ADDENDUM NO. THREE (3)

Project: Gwinnett County Campus Wayfinding Signage, BL073-26

Contract for: Campus Wayfinding Sign Fabrication and Installation

WAYFINDING
 SIGNS 17-23

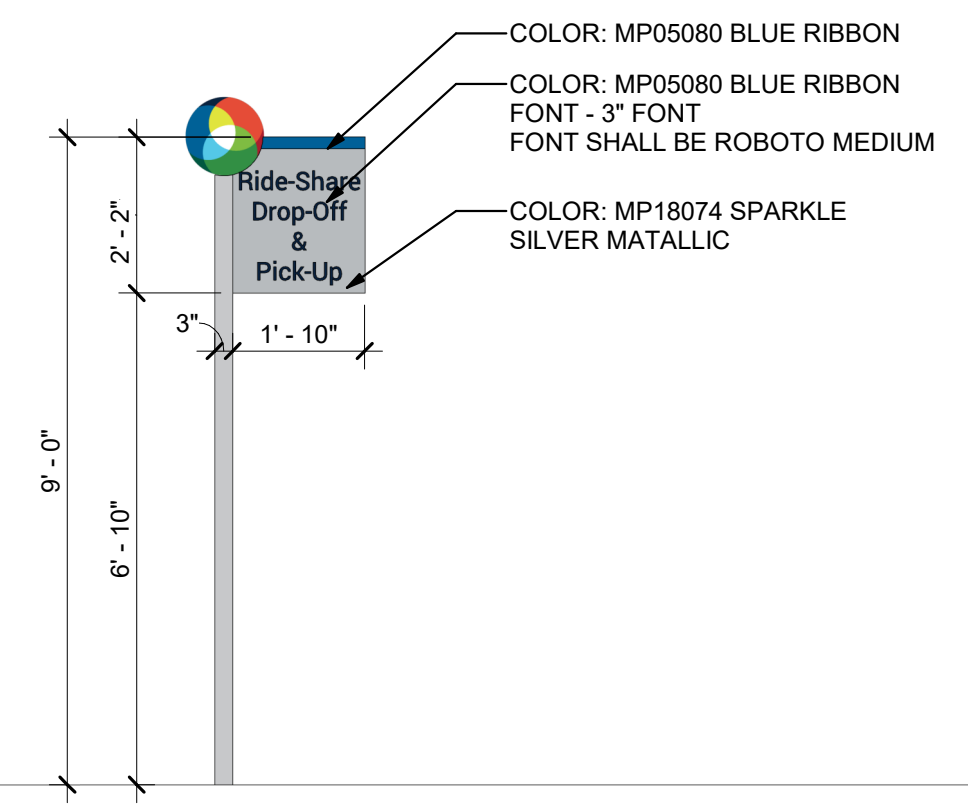
Q3. The "Typical Section at Sign Panels" detail that was added above Sign 4, is that for the poles or is this for the double-sided sign? It calls out a 4" Aluminum Frame Signage Panel – I'm a little lost on this detail if you have any clarification?

A3. **This is a typical detail showing a section cut of the double post and bar signs. During the questions process one of the requests was a detail showing this.**

Sign 23 (Side 1)
 Location: Facing Perry Street
 Type: Double Post and Bar Sign

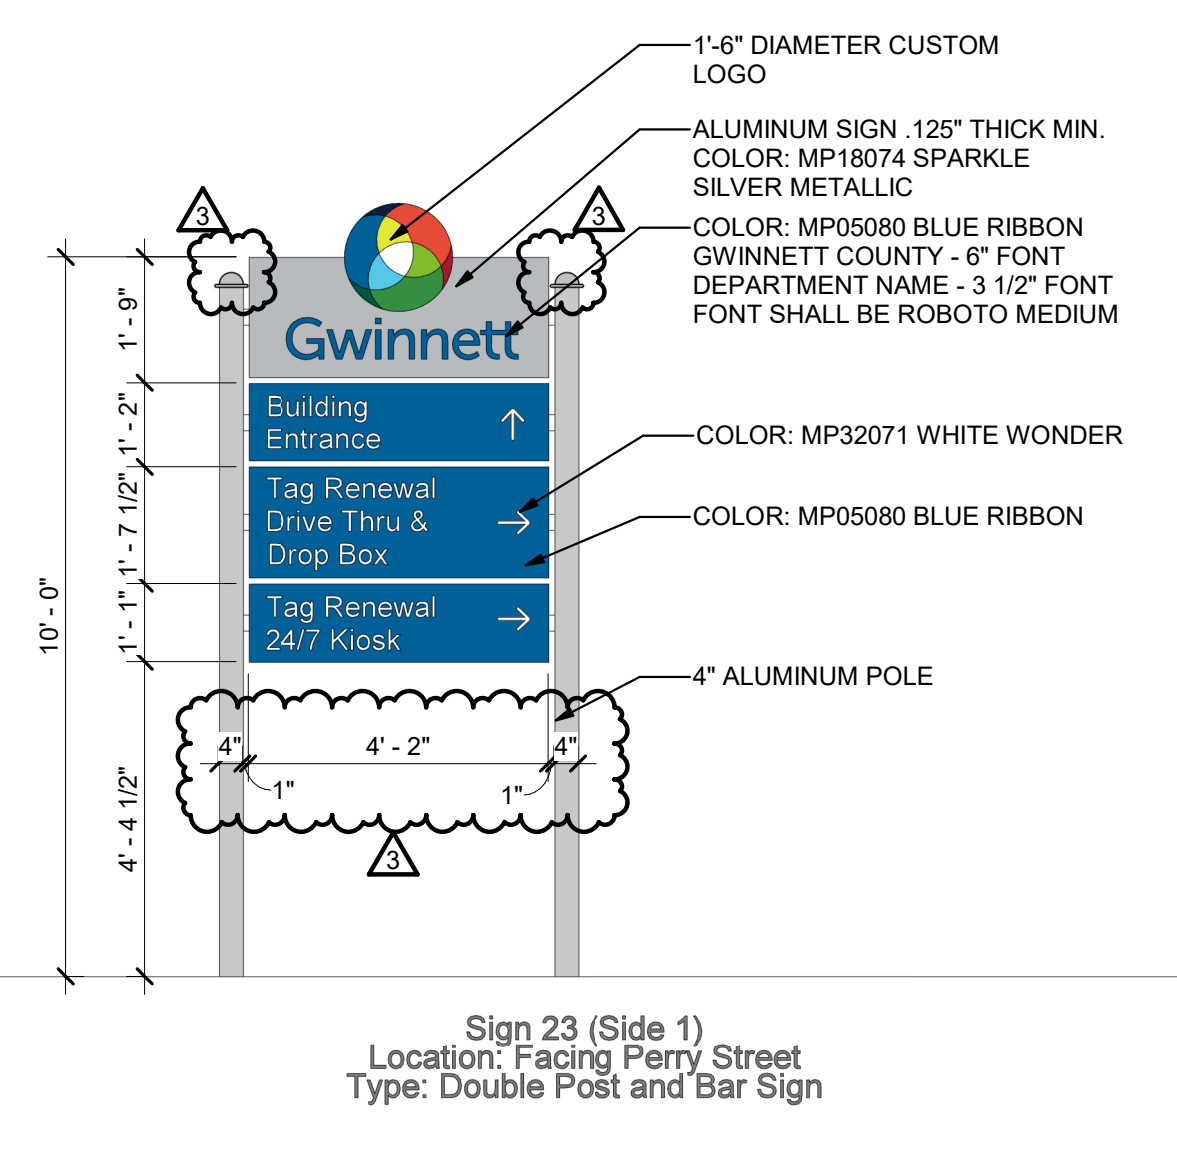
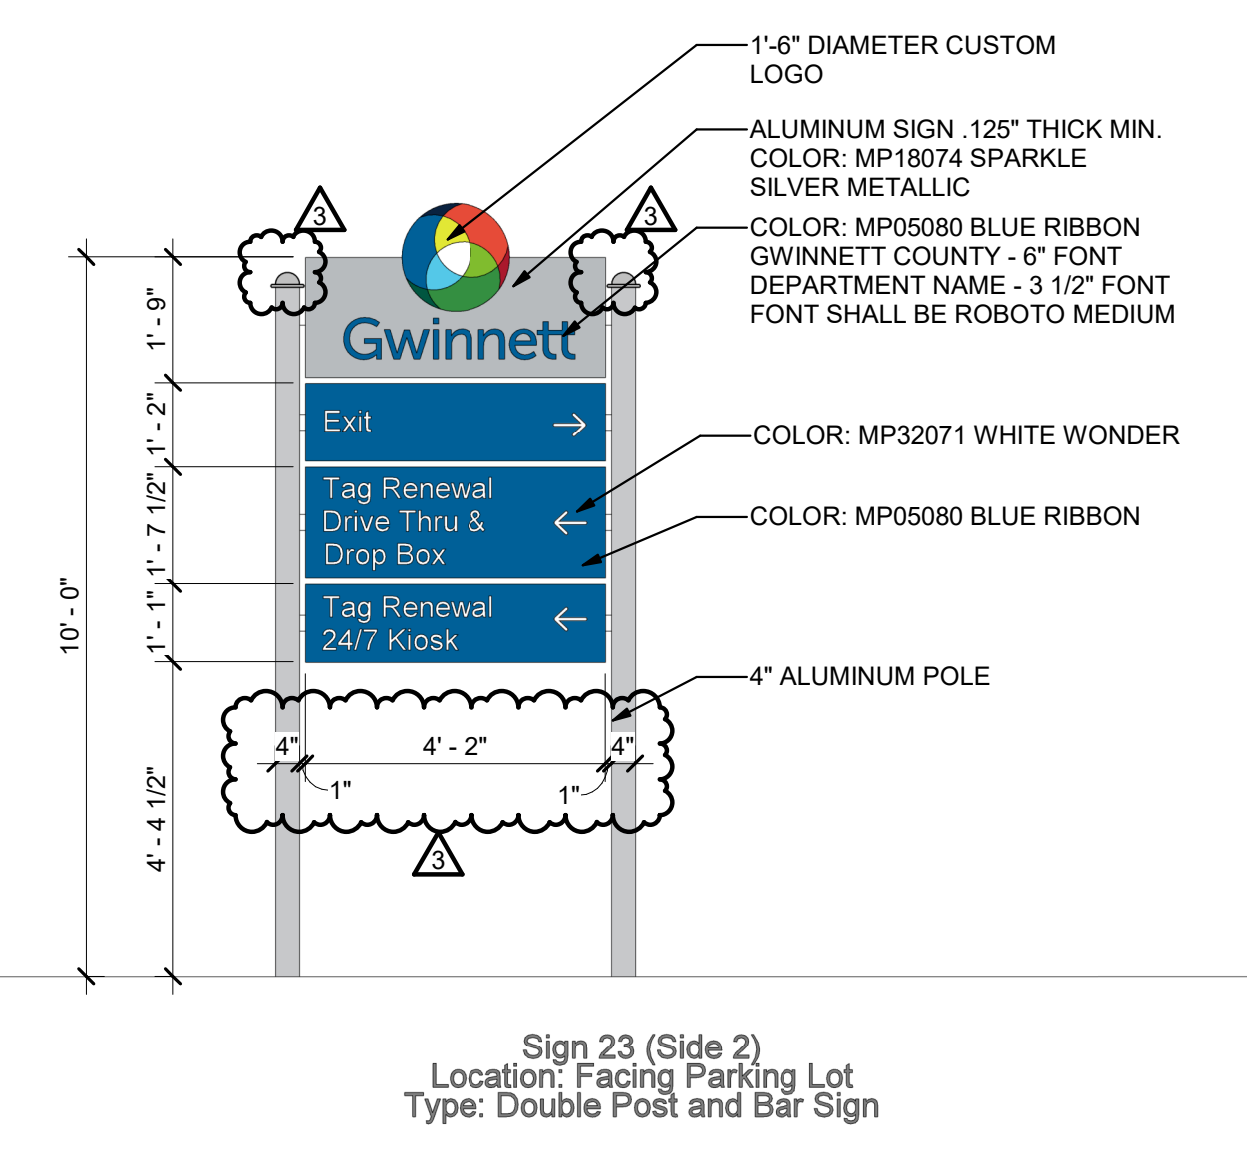
A1.4 – Dome Caps added to Sign 23, Dimensions to clarify width added to Sign 23.

Q1. The three new signs do not have dome caps on the poles, should those be included?

Q2. There isn't a width provided for the double-sided, Sign 23; I assume it matches the 6'-3"W?

A1. **Yes include dome caps. Refer to the attached A1.4.**

A2. **All Double Post and Bar Signs are 5'-0" Wide. Refer to the attached A1.4.**
